Subject: Request for Revision of National Pollutant Discharge Elimination System  
(NPDES) Permit No. IL0005037

Subject: Request for Revision of Quad Cities Station NPDES Permit  
NPDES Permit No. IL0005037

**REVISED TEMPERATURE MONITORING CURVE FOR  
QUAD CITIES NUCLEAR GENERATING STATION**

Figure 2. Revised Temperature Monitoring Curve.

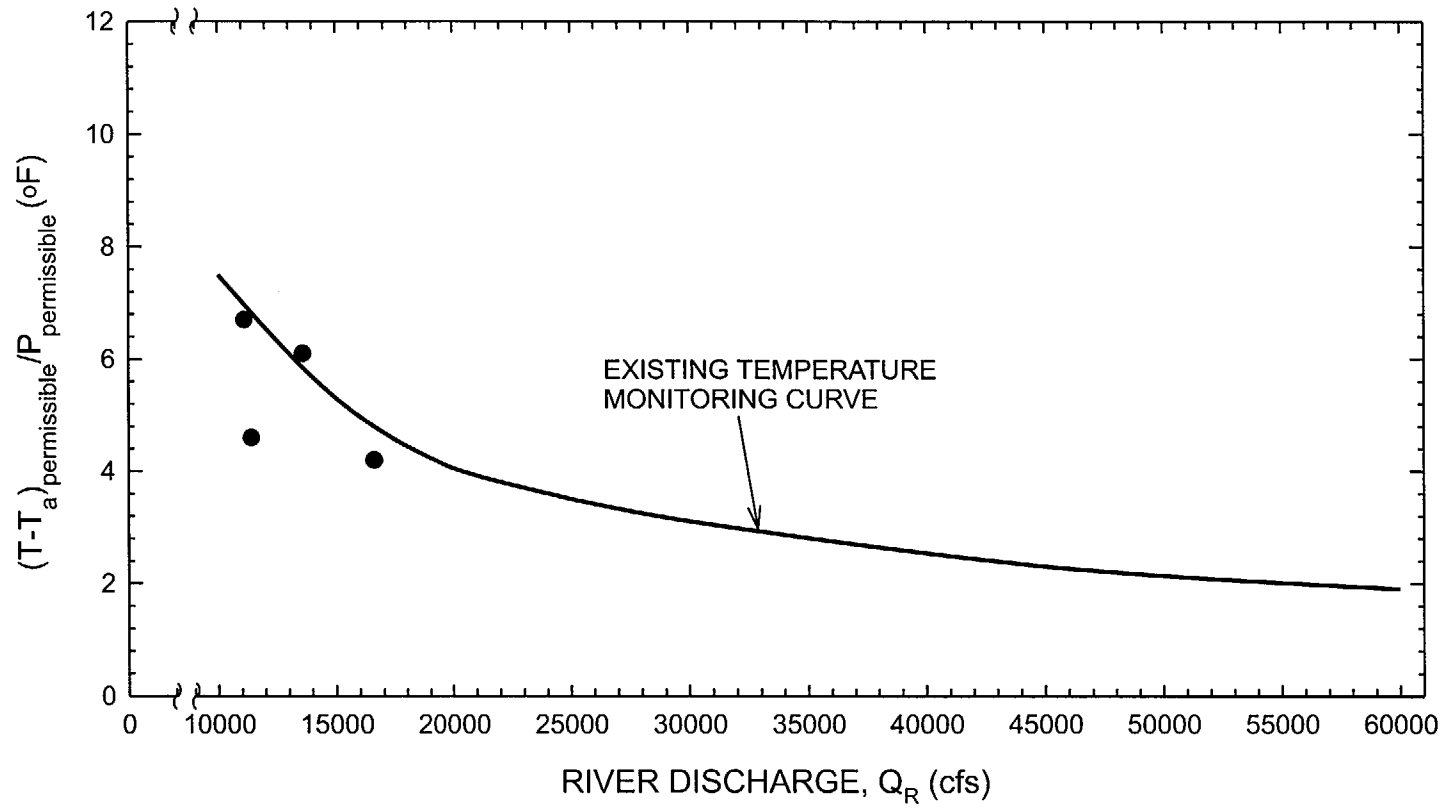
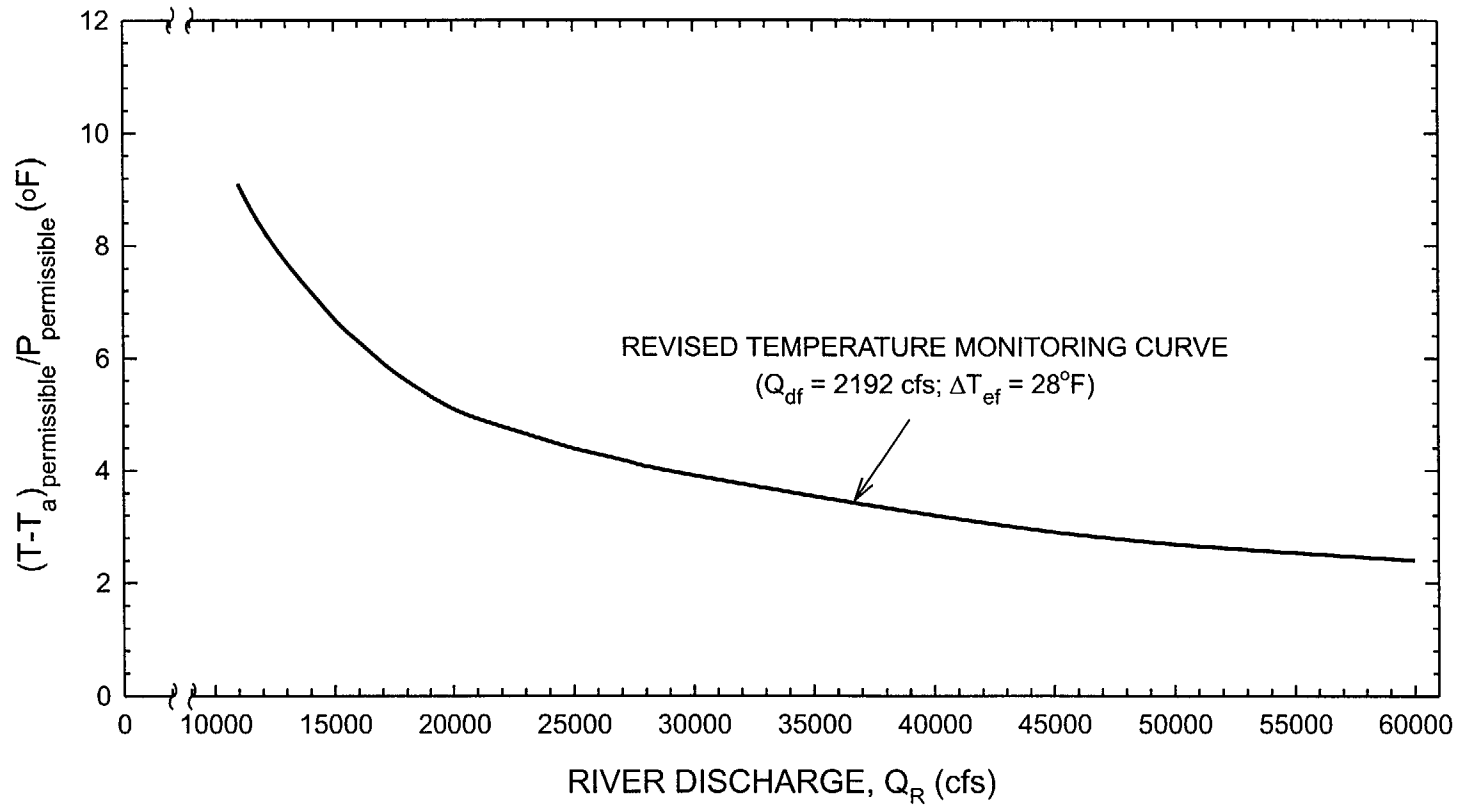
<sup>1</sup>**The revised temperature monitoring curve identified as Figure 2 in the December 2000 "Revised Temperature Monitoring Curve for Quad Cities Nuclear Generating Station."**

In connection with the EPU project, Exelon retained Dr. Subhash C. Jain to revise the temperature monitoring curve to reflect an increase in the discharge temperature of 5.0°F. Dr. Jain was one of the principle investigators responsible for conducting the 1990 study

that established the temperature monitoring curve referenced in the current permit. The report "Revised Temperature Monitoring Curve for Quad Cities Nuclear Generating Station" is enclosed for your review. The revised temperature monitoring curve indicates that at river flows of 21,100 cfs and greater, sufficient mixing is observed in the river to conclude that at any power level, the plant will not cause exceedence of the permitted thermal limits. Exelon proposes the Agency revise the permit to reflect this value and change Footnote 1 to reflect the revised temperature monitoring curve.

The existing TMC can be modified for applicable to the revised maximum effluent discharge and excess temperature by multiplying its ordinates by the ratio  $\alpha = 1.27$ . The revised TMC is presented in Figure 2.
